# Rezoning Transportation Analysis

Petition Number: 2023-160

Date	Description
12-27-23	First Review (JP)

**1. Curblines:**

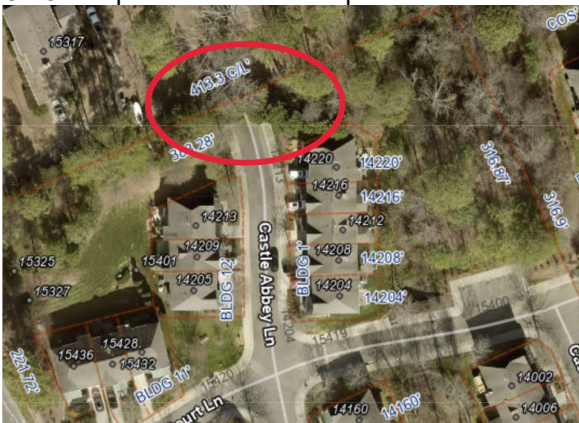
- a. **Marvin Road:** Curb and gutter to be installed 24' from the centerline for a 2+ Avenue with a bike lane as shown on Charlotte Streets Map.

Label and dimension the curb and gutter from the centerline for each road on the site plan.
